MONITORING YEAR 0 ANNUAL REPORT

COOL SPRINGS MITIGATION SITE

DMS Project No. 100166
NCDEQ Contract No. 0302-02
DMS RFP No. 16-20190302/Issued: December 20, 2019
USACE Action ID No. SAW-2020-01400
DWR Project No. 2020-1279

Subject: DMS Comments on the MY0 and As-built/Record Drawings
DMS Project Number 100166
Harnett County, North Carolina
DMS Contract Number 0302-02

1.7.2

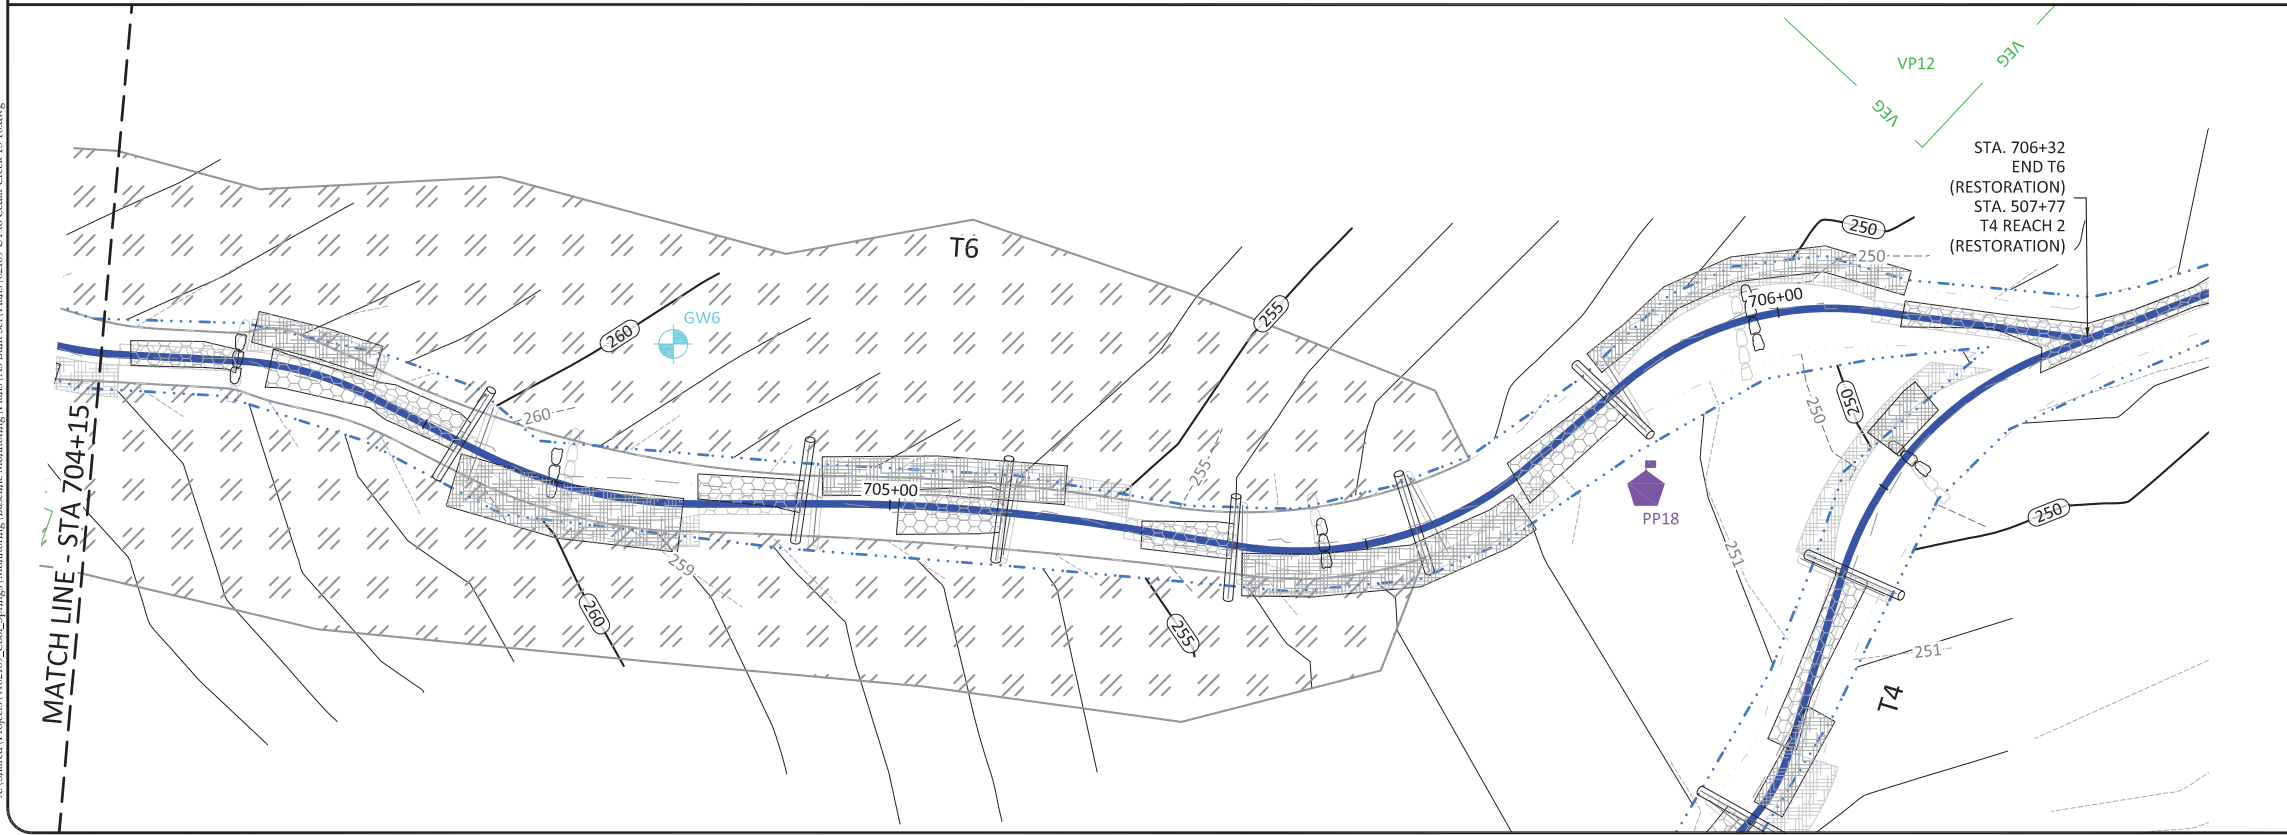
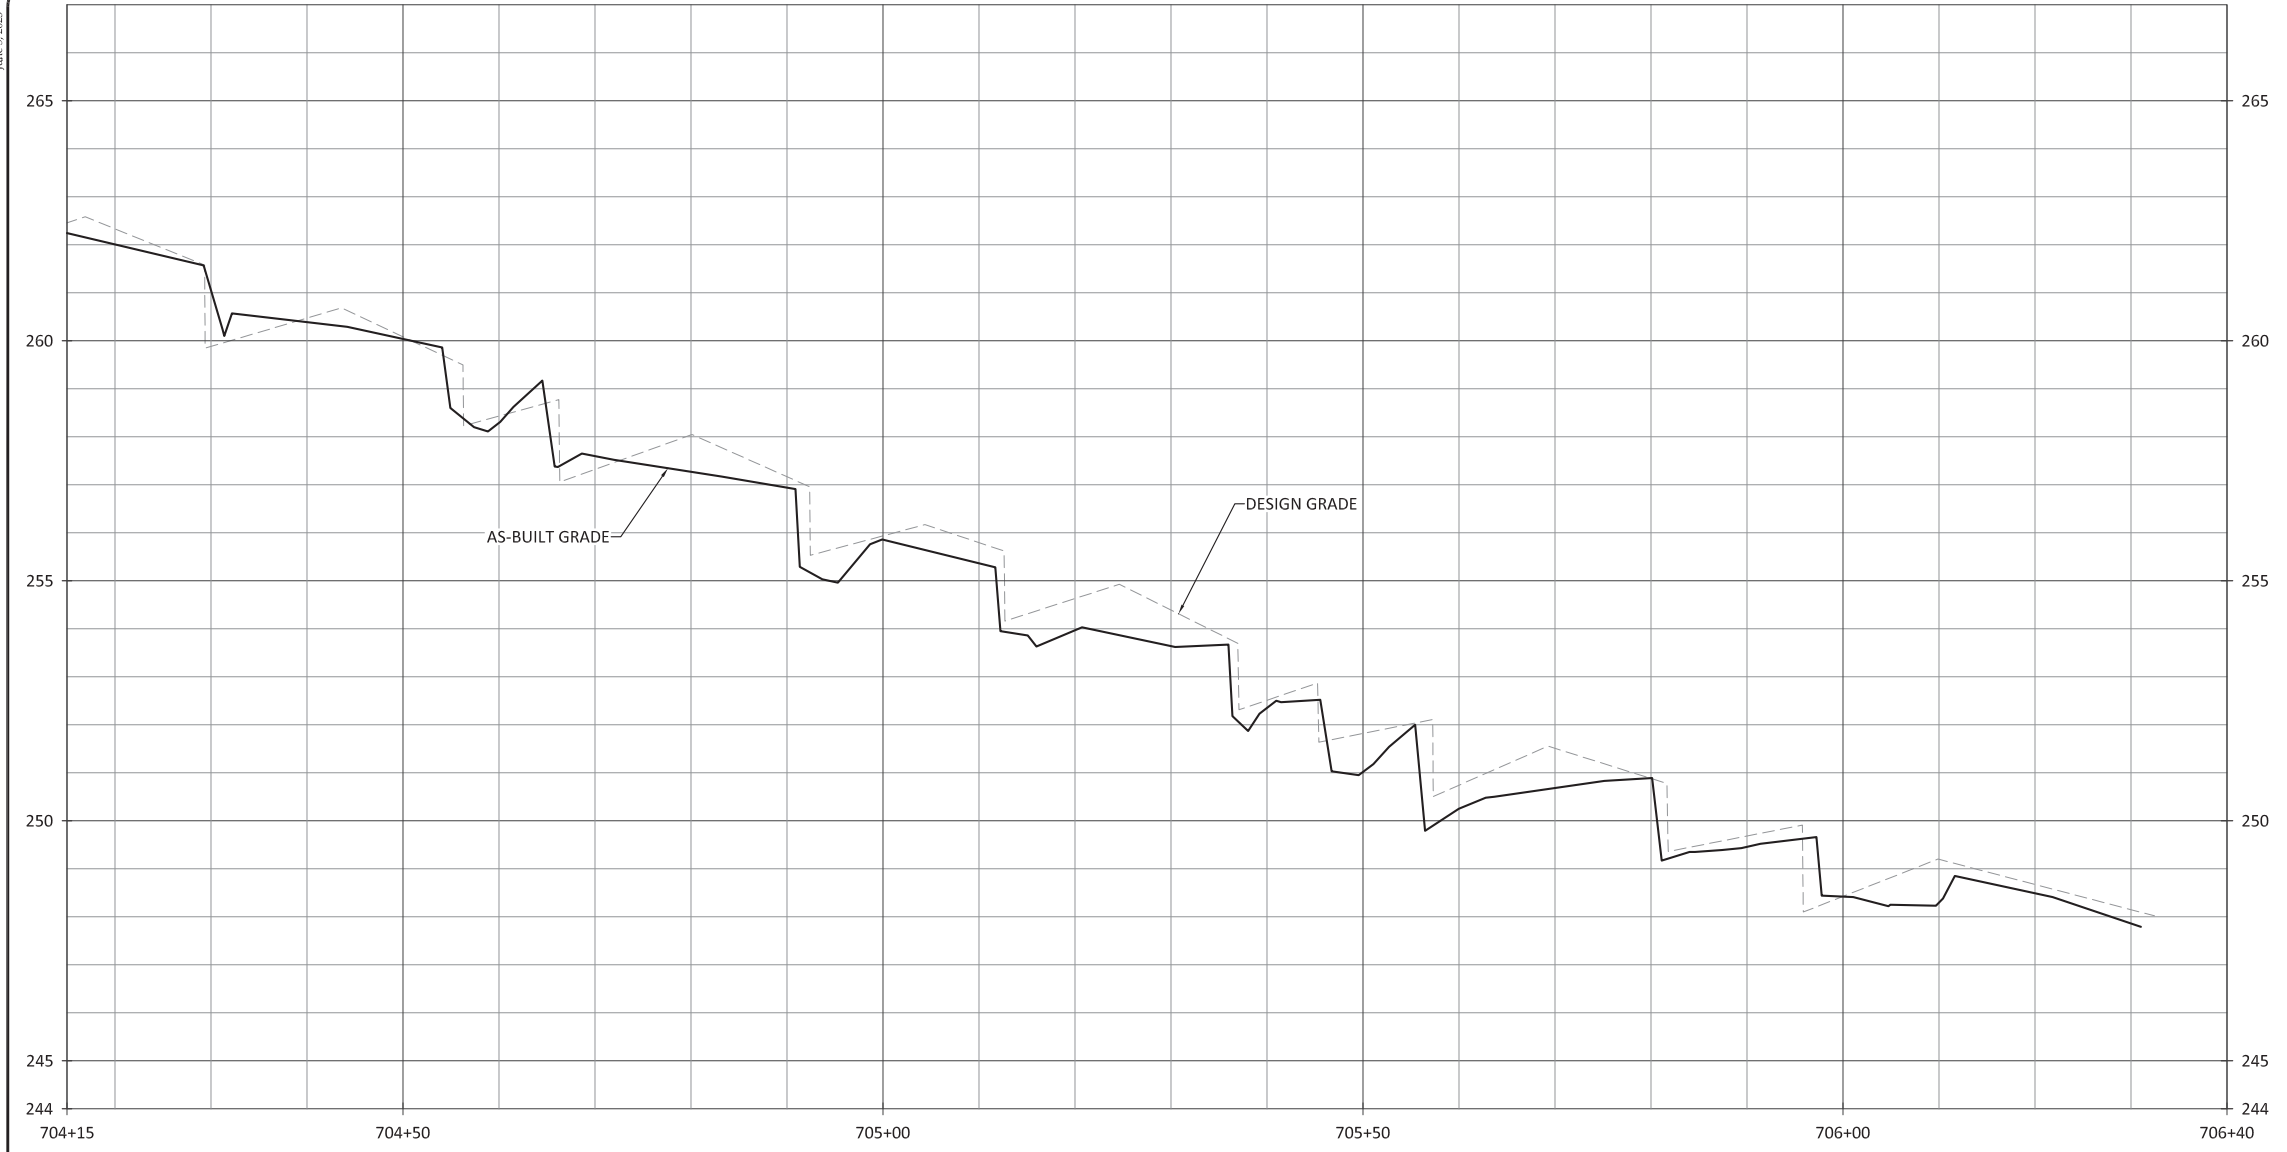
7. On T6 (see Sheets 1.7.1. & 1.7.2) log sills at STA 702+03 and STA 702+64 were called out as replaced with a boulder sill, but field observations during the visit indicate that the log sills were installed as designed. Please remove these callouts from the drawings and section 2.1.11.

The callouts on record drawing sheets 1.7.1 and 1.7.2 and report section 2.1.11 referencing log sill replacement at STA 702+03 and STA 702+64 have been removed.
